Revision History

## Schematics taken from P151-A00-X24 MS-8889 00A

602-10085-0000-A03 140-10085-0000-A03

## 1.c NV28 .. PLL / DAC / I2C

## 100-0819

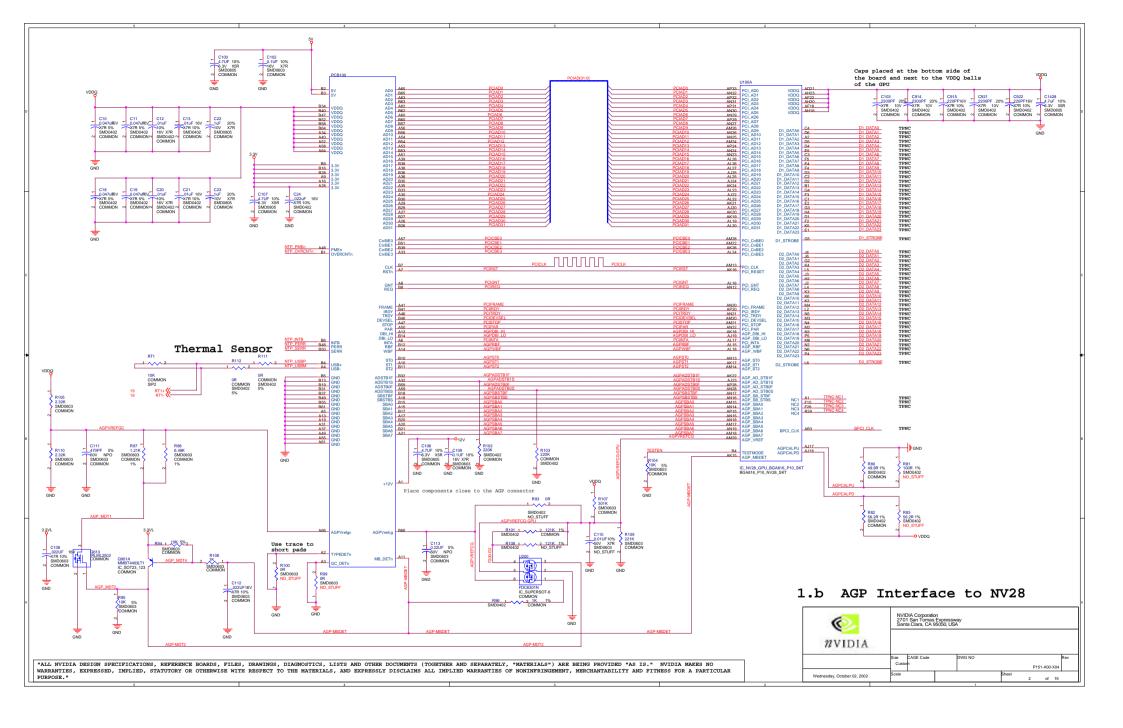
```
1)Page 16,17 - Remove C1263,C2267,C2301,C2303,C2309,C2310 for layout.
2)Page 16,17 - L801,L802 change Footprint to CHK_3052_08.
3)Page 3 - change R1107 to 113R and change R927 to 110R
4)Page 10.12 - C325.C320.C1120.C1121 from 22PF change to 47PF
```
